## **1- ACCESSORIES FEEL AND LOOK**

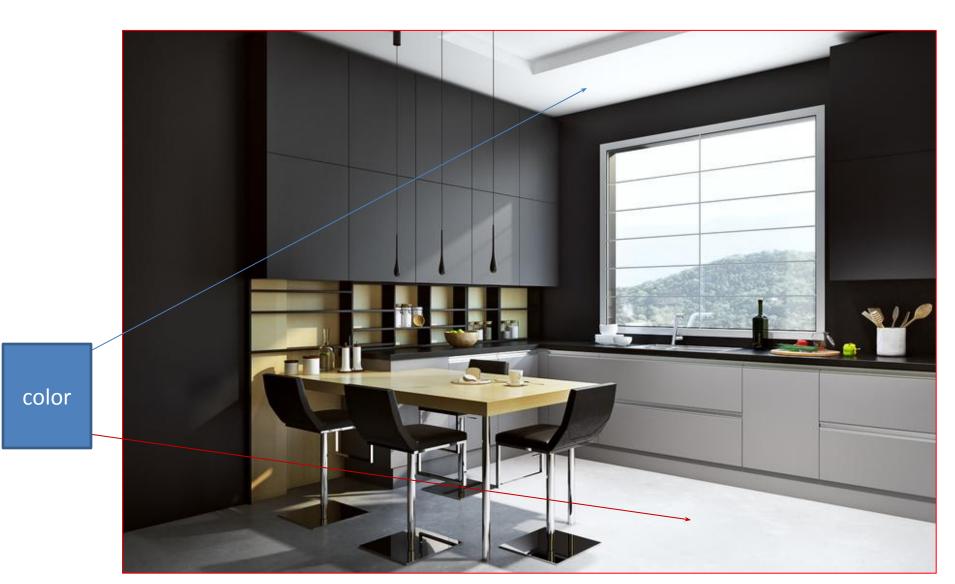
#### Please check the accessories on the table and on the countertop

Now kindly compare them with the accessories in the upcoming pages, do they look real? Especially the bottle, cup of coffee, cheese, bowl, vegetables

## **3- FINISHING**

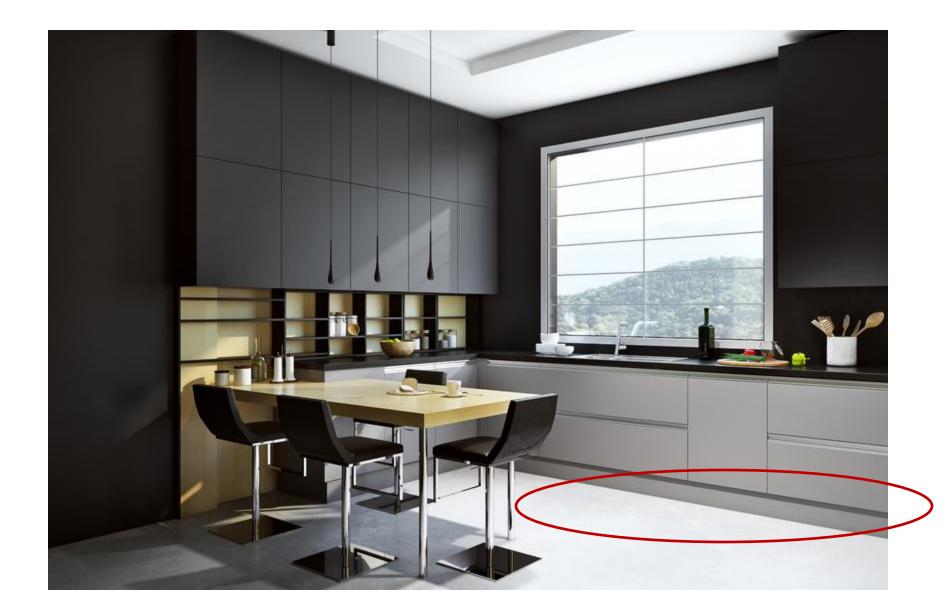
The positioning of the oven + microwave from left and right side is wrong. Also these items doesn't look real

#### Now please check the positioning and finishing of the oven in this pic

# Both frames should be on the same level

#### Please check the skirting finishing it doesn't look realistic

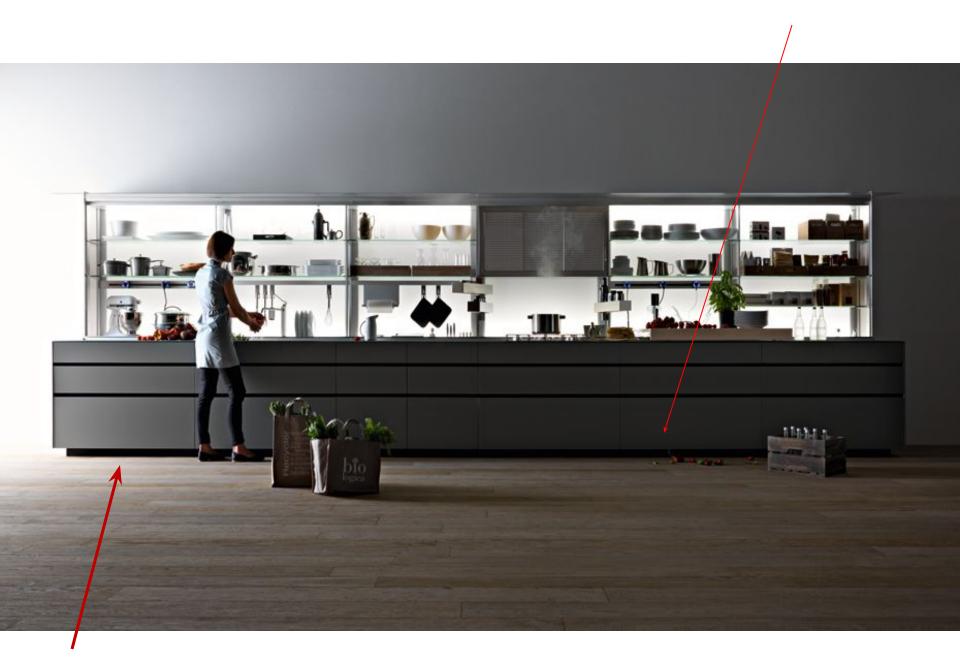
# Now check these 2 pics showing the effect , the color and shadow

### **4- COLORS**

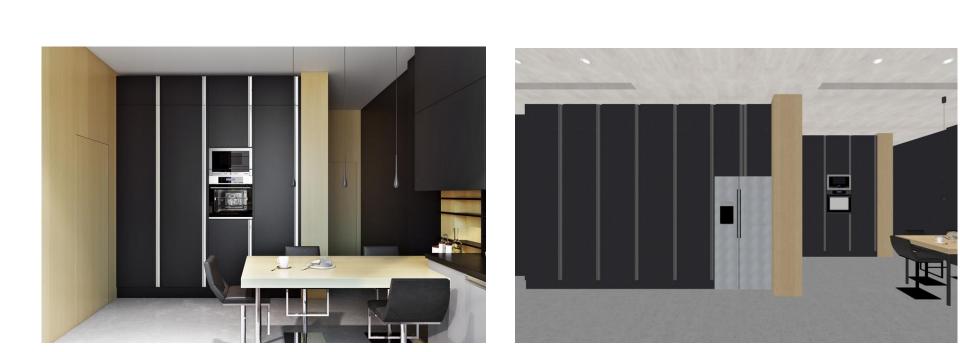
It looks fake because of the high contrast and the uniformity of colors. You can't find a mass of black everywhere in real life.

Now please check the black color in this picture. It is the same product used in wall unit. Also check the lightning and the wall
